Value Engineering For Transportation Improvements

SR 429 (Wekiva Parkway)/SR 417 and I-4 Interchange

Value Engineering Study Final Report

Project Description: Wekiva Parkway/SR 417 and I-4 Interchange

RECOMMENDATION No. 25: SR 429 westbound off ramp reconfigure to two lanes

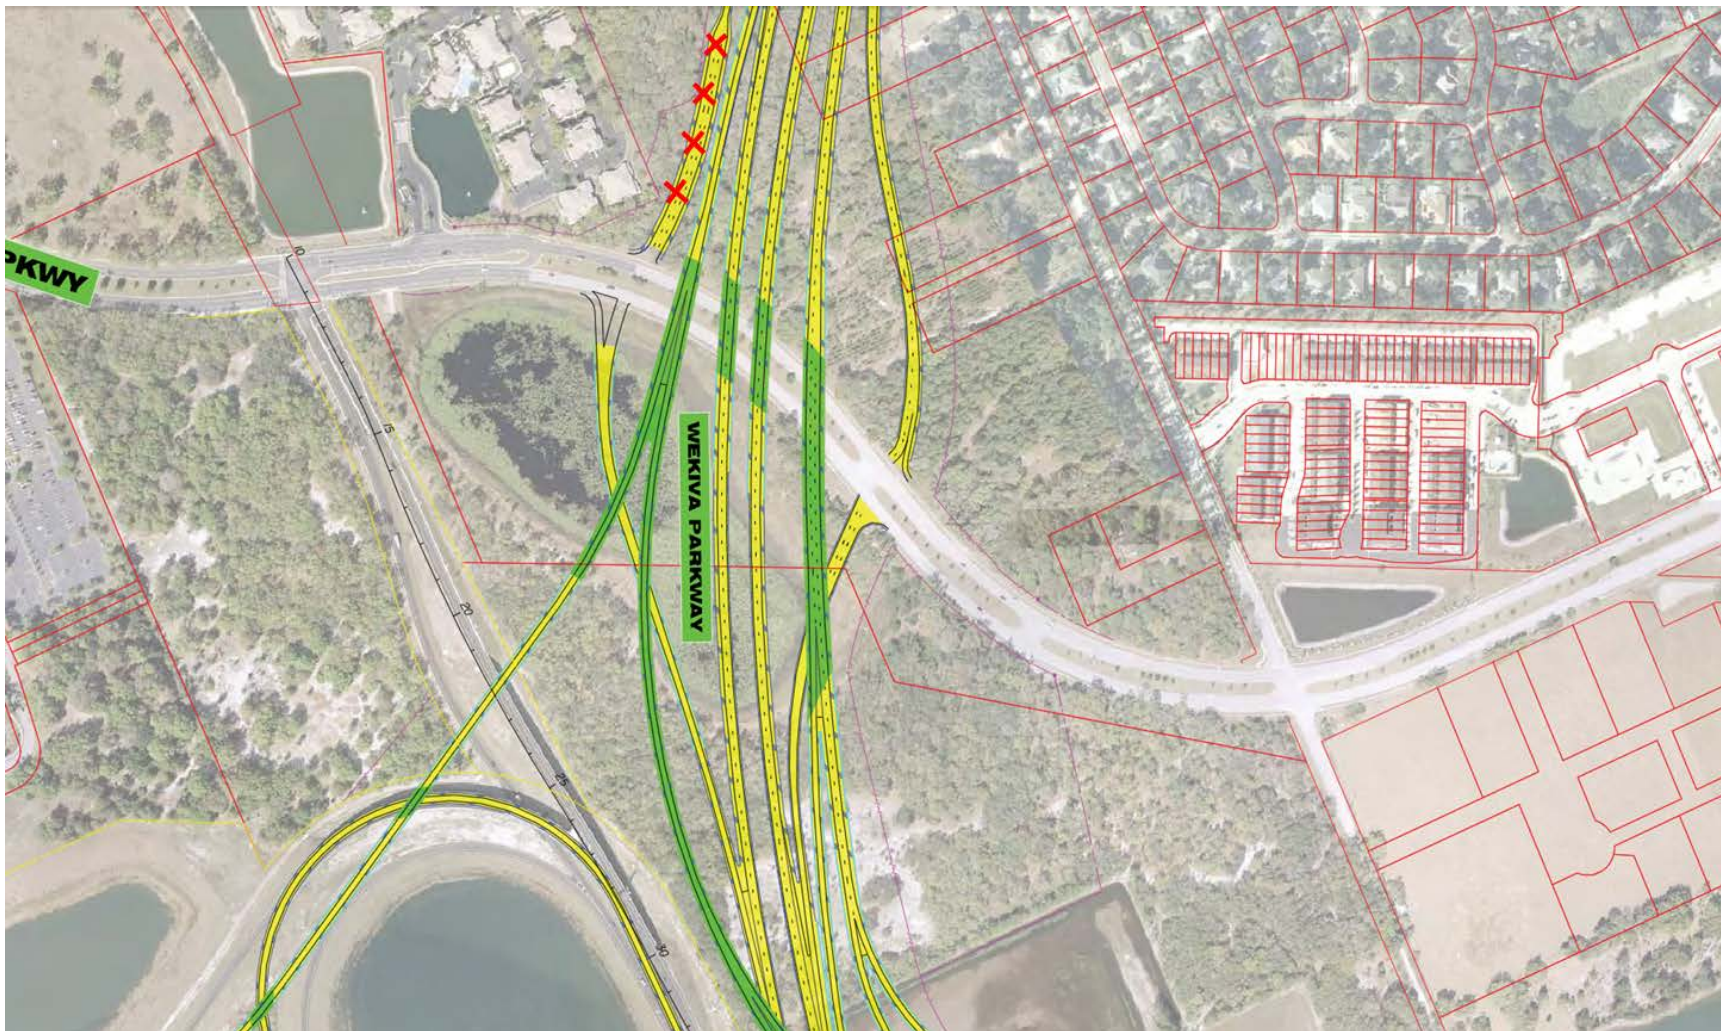
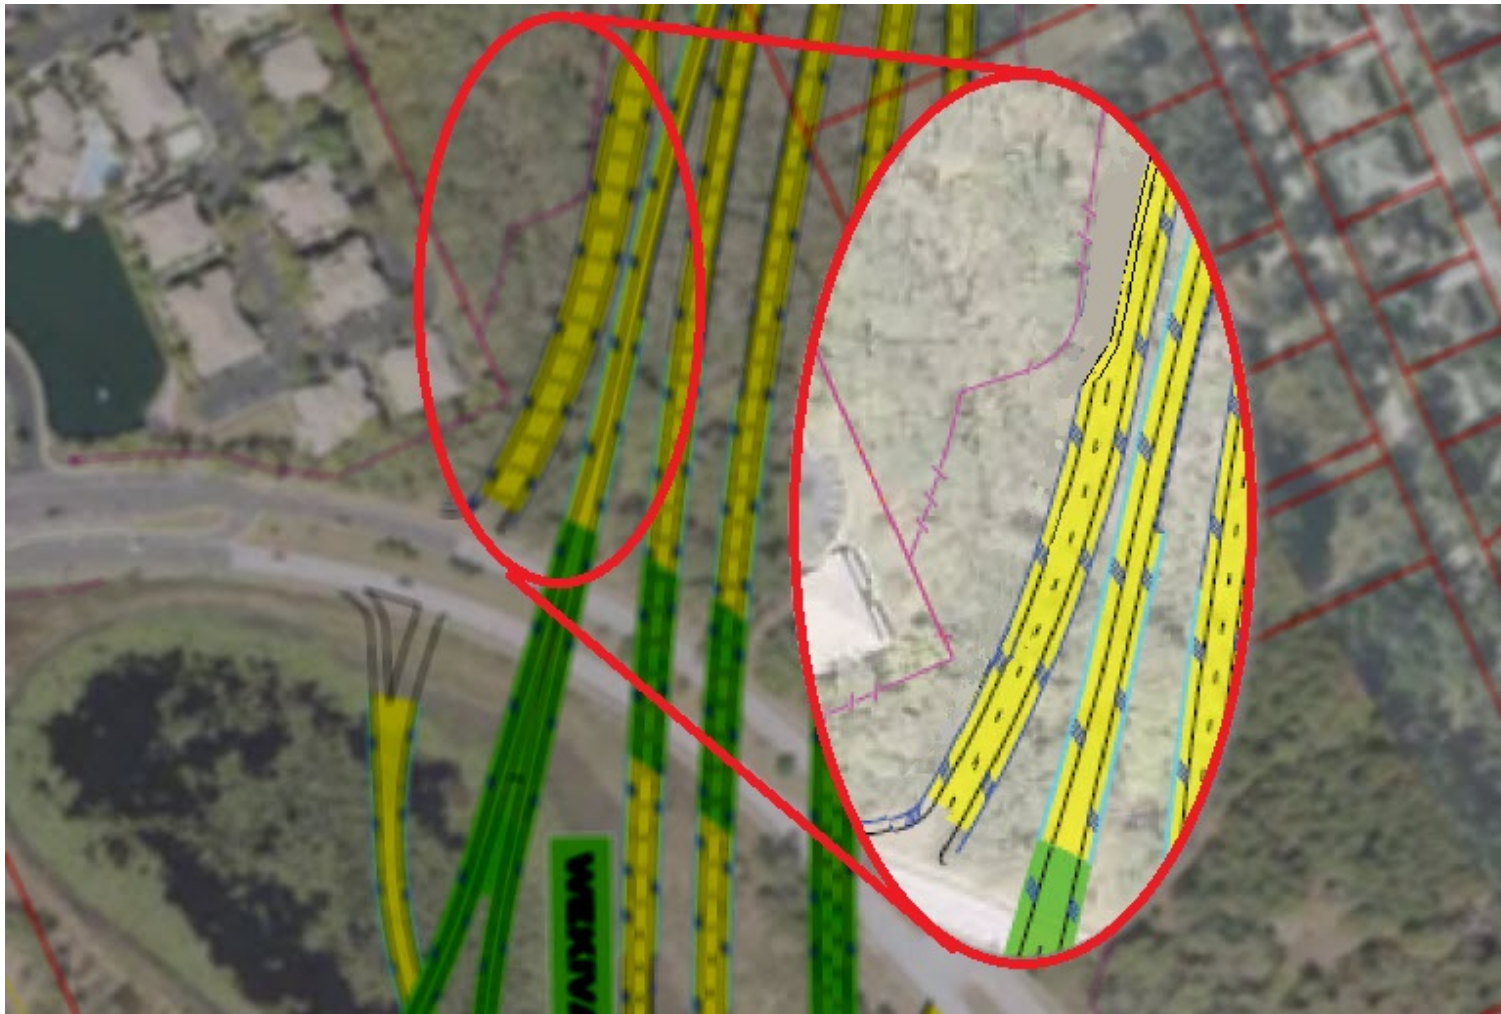
The PD&E Documents show the SR 429 westbound off ramp to International Parkway with three lanes, two left-turn lanes and one right-turn lane.

Accepted. It appears based upon the revised traffic numbers that dual left turn lanes are no longer required so this ramp could be reconfigured. During the line and grade phase this recommendation will be fully evaluated. (Atkins)

RECOMMENDATION No. 28: Modify the SR 429 eastbound to I-4 westbound ramps to go under I-4 and the C-D road

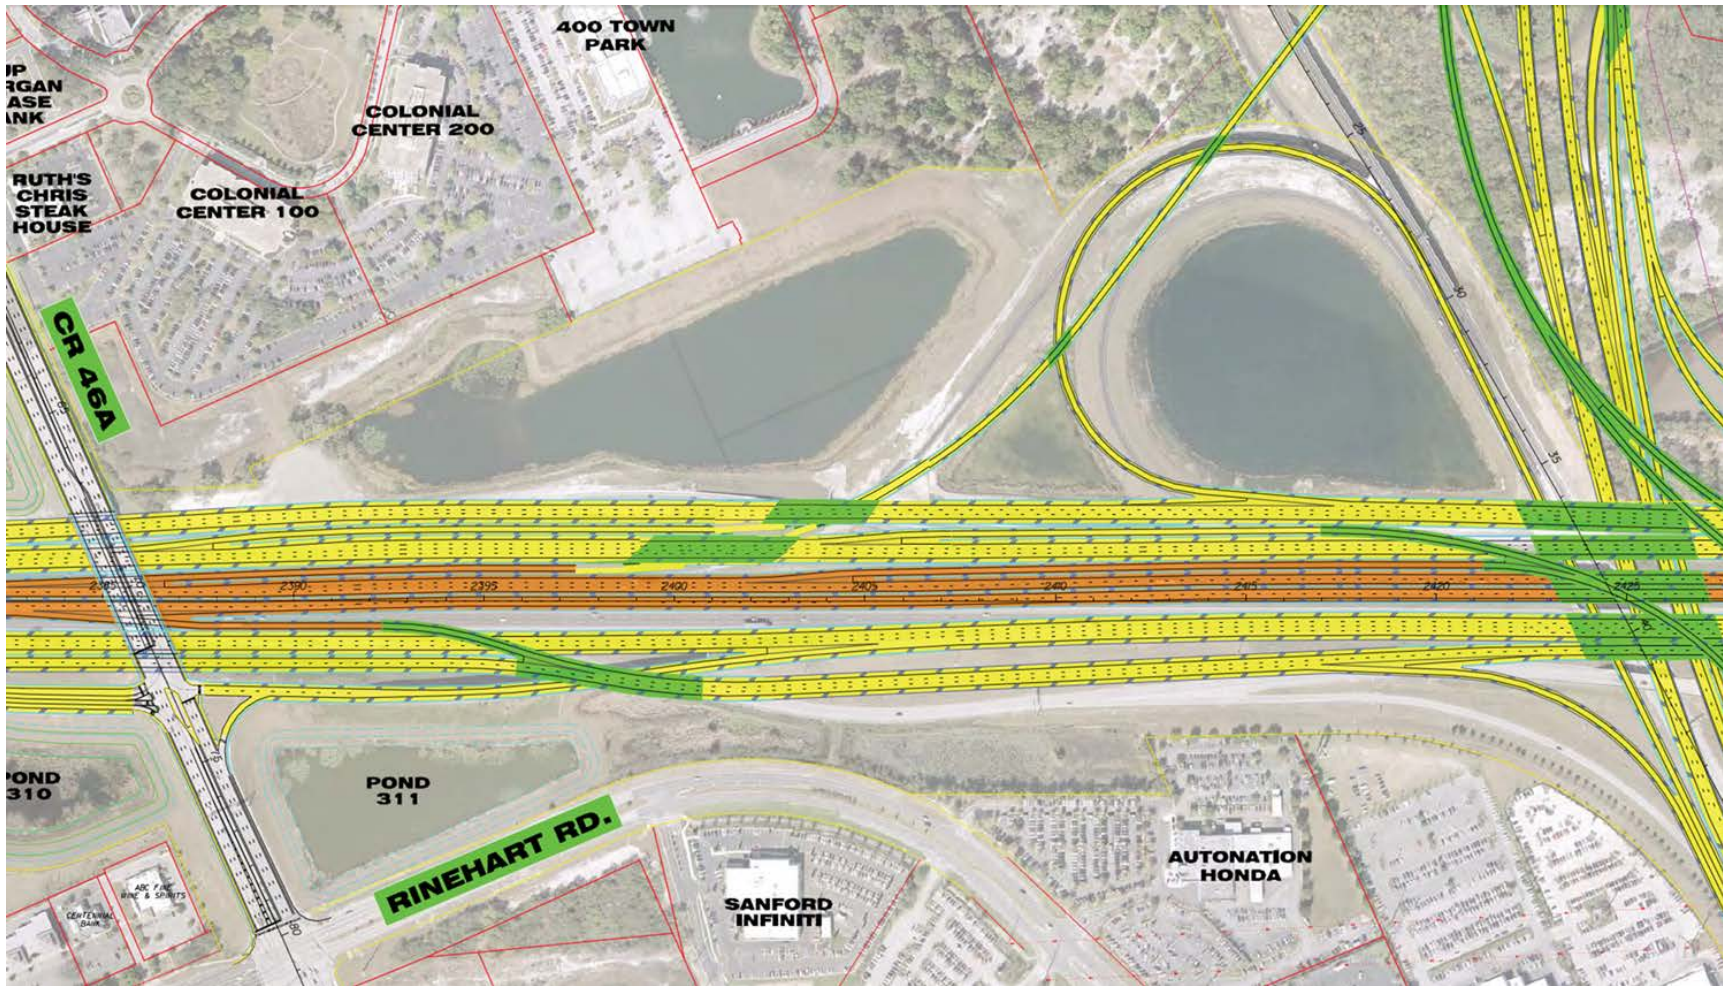
RECOMMENDATION No. 28: Modify the SR 429 eastbound to I-4 westbound ramps to go under I-4 and the C-D road

RECOMMENDATION No. 29: Not replacing the bridge and reroute the Cross Seminole Trail up to CR 46A and incorporate the Trail in to a nice pedestrian crossing at that location

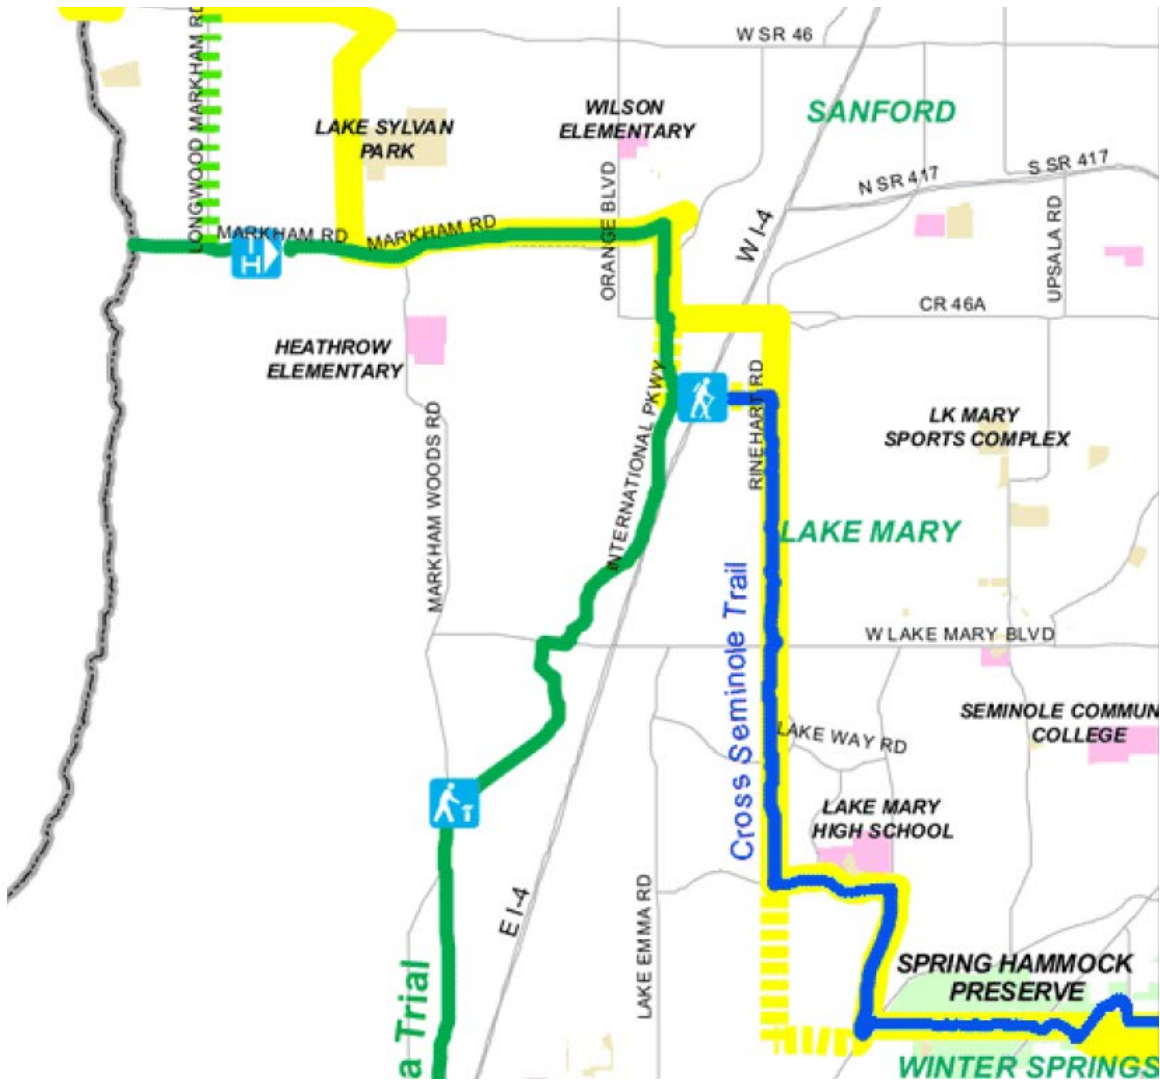
The I-4 Re-evaluation Segment 3 PD&E proposes to impact and replace the existing Cross Seminole Trail Pedestrian Bridge.

- Connectivity for the two existing trail systems will be revised but maintained utilizing the CR 46A corridor. Will not maintain a separate dedicated trail system.
- Additional right-of-way may be required along CR 46A corridor between International Parkway and Rinehart Road to accommodate a multi-use trail than the traditional pedestrian features with sidewalk.
- It is anticipated the I-4 Pedestrian Trail Bridge will require an in-kind bridge replacement

Not Accepted. The concept has been modified to not impact the pedestrian bridge crossing I-4 so rerouting the Cross Seminole Trail will not be necessary.

RECOMMENDATION No. 31: Eliminate the C-D road in the southeast corner of the interchange

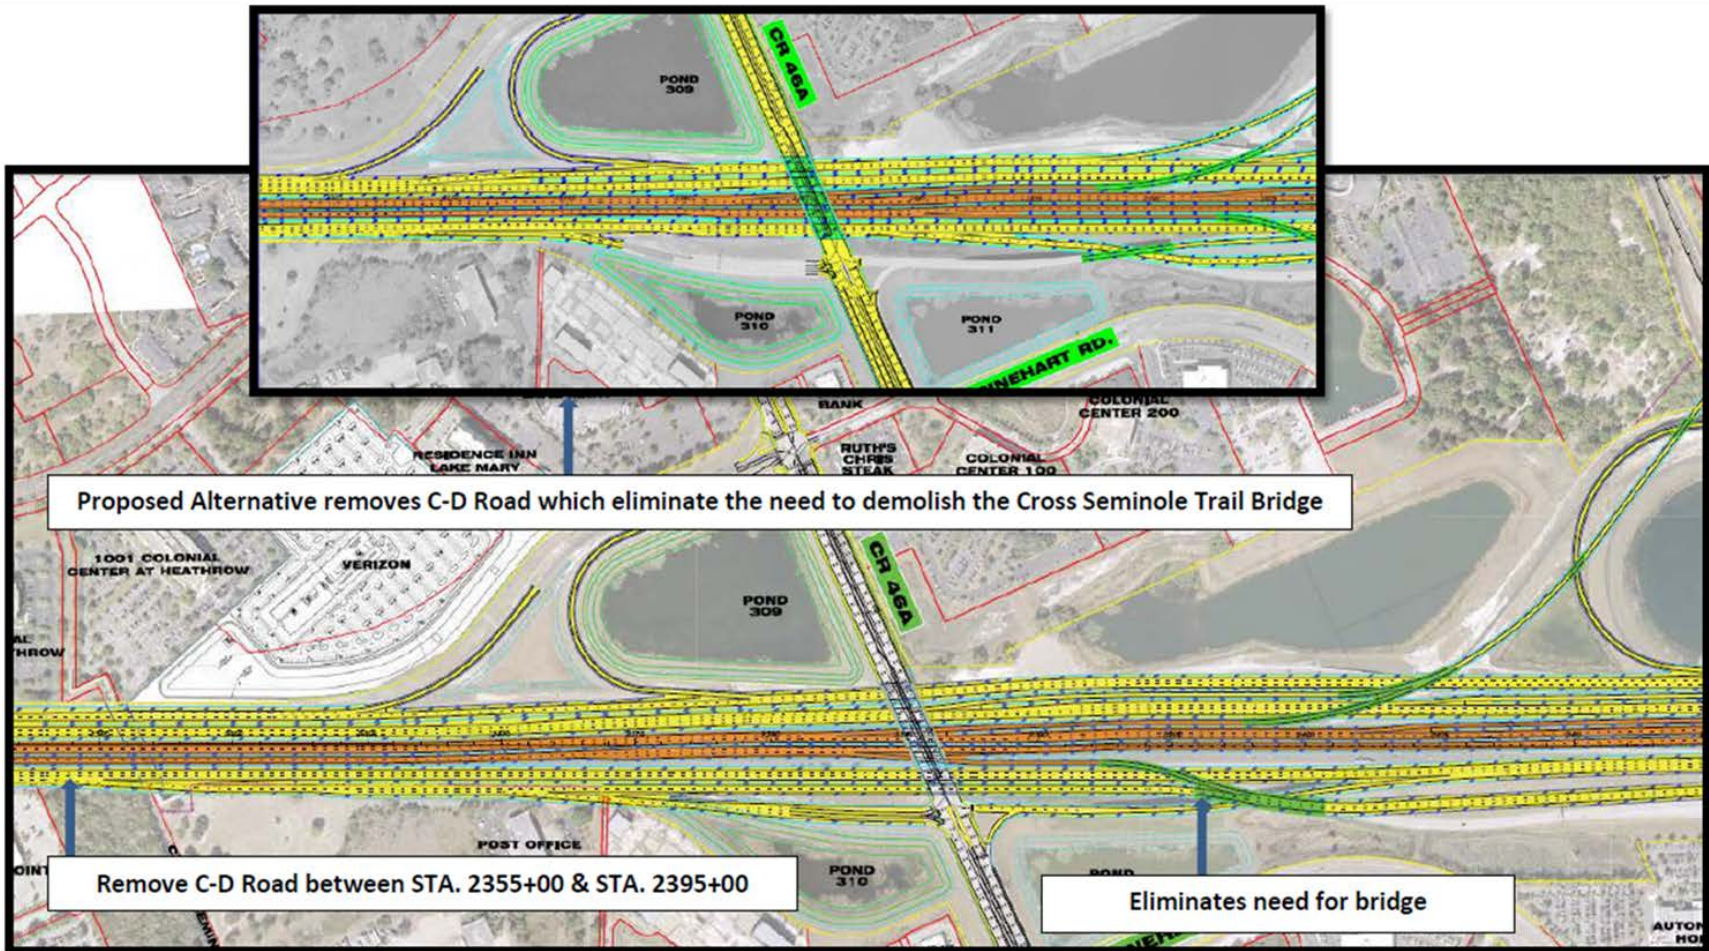
The PD&E Documents show the use of a C-D road starting at the Cross Seminole Trail connecting the main line of I-4 south of CR 46A. The C-D road is then brought over the CR 46A on ramp before continuing on to the SR 417/SR 429 Interchange.
